ROLLING MEADOWS CHANNEL & FLOODPLAIN MODIFICATION

60% DESIGN PLANS
MARCH 2023

MATRIX PROJECT No. 21.1129.009

THE LANDHUIS COMPANY			
ROLLING MEADOWS CHANNEL & FLOODPLAIN MODIFICATION 60% DESIGN PLANS			
PLAN AND PROFILE STA. 92+06 - 106+00			
DESIGNED BY: TKM	SCALE: HORIZ 1" = 100'	DATE ISSUED: MARCH 2023	DRAWING No. PP10
DRAWN BY: EAL	VERT. 1" = 20'	SHEET 19 OF 47	
CHECKED BY: AJS

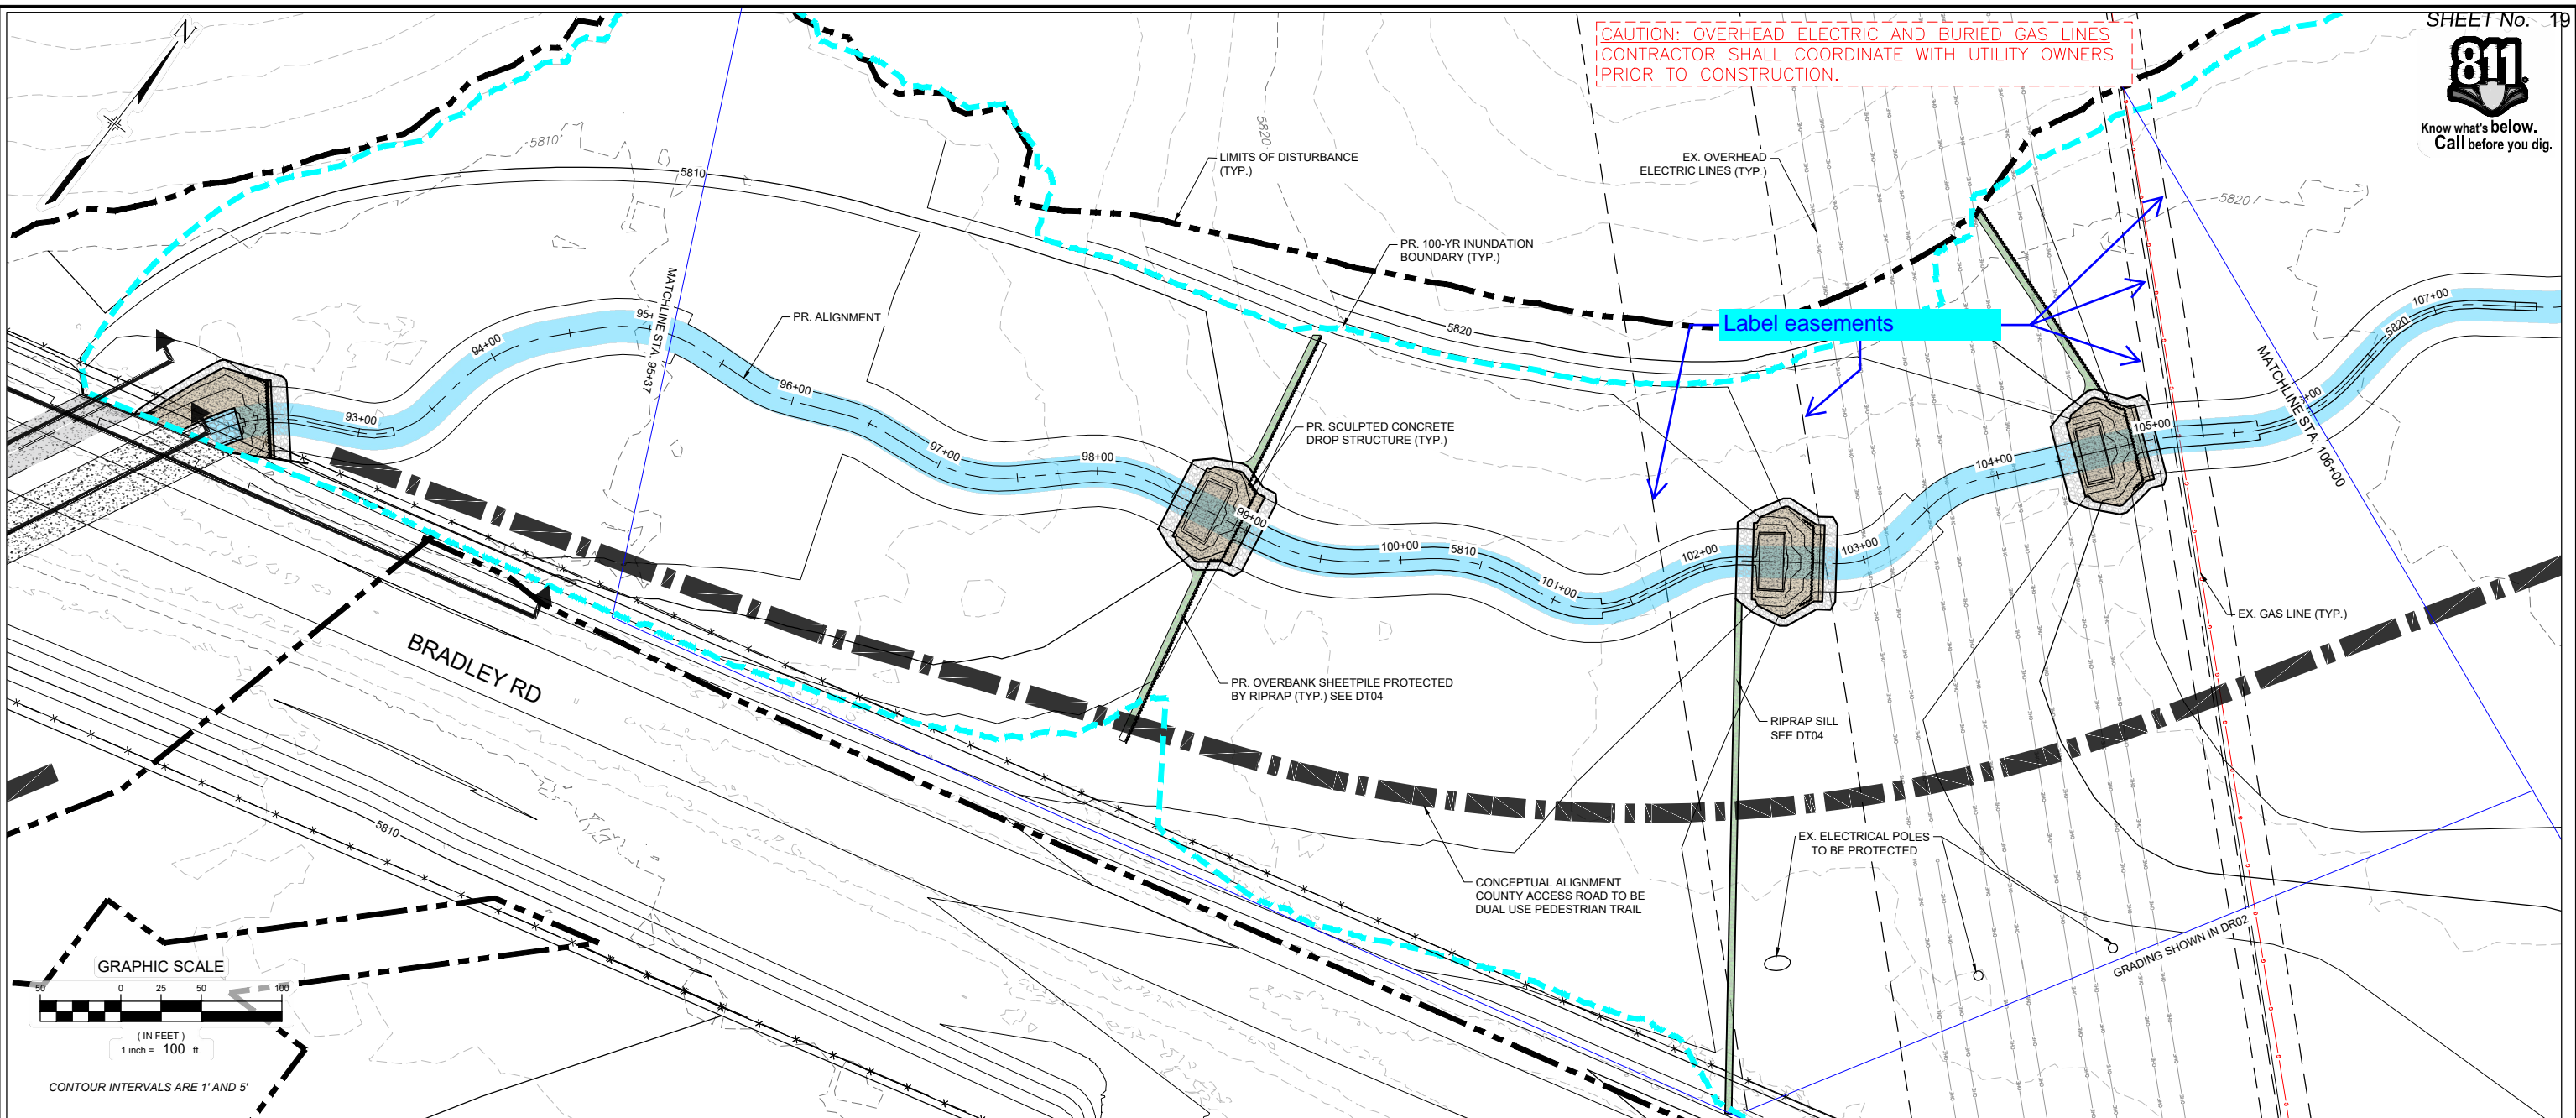
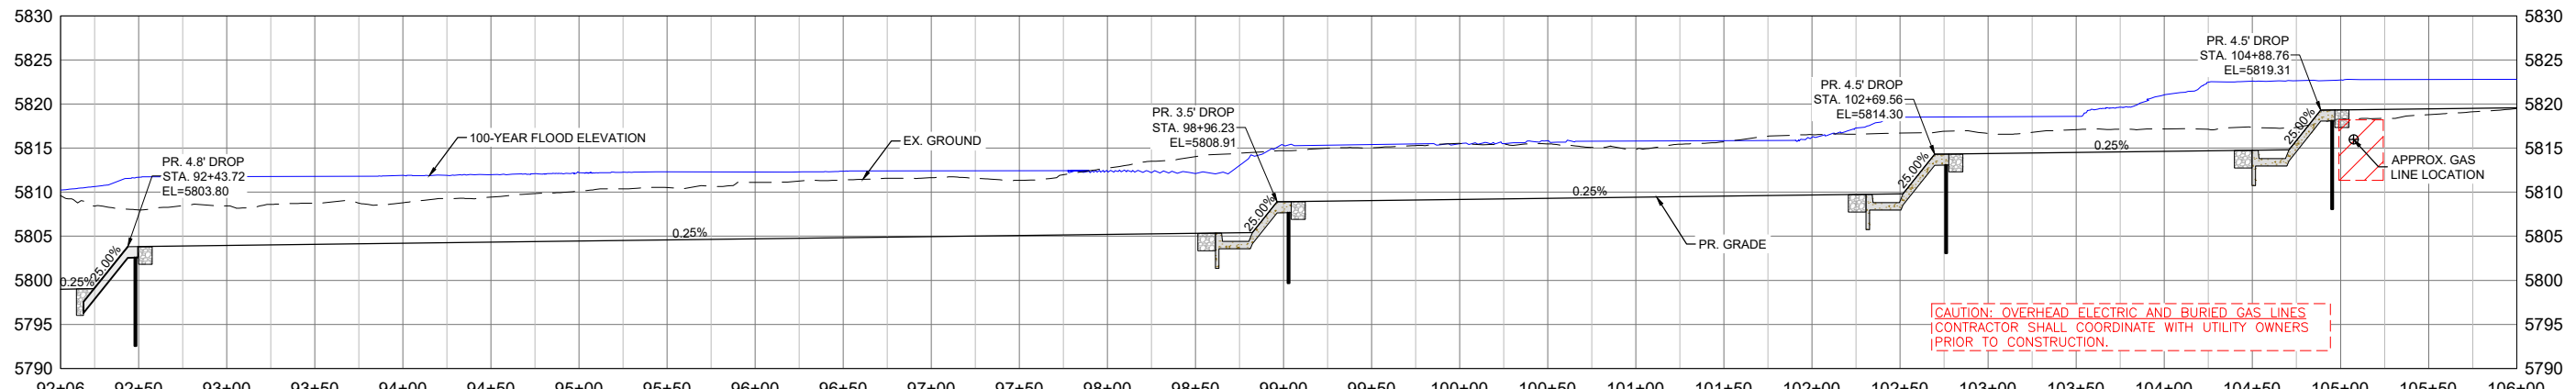
Label easements
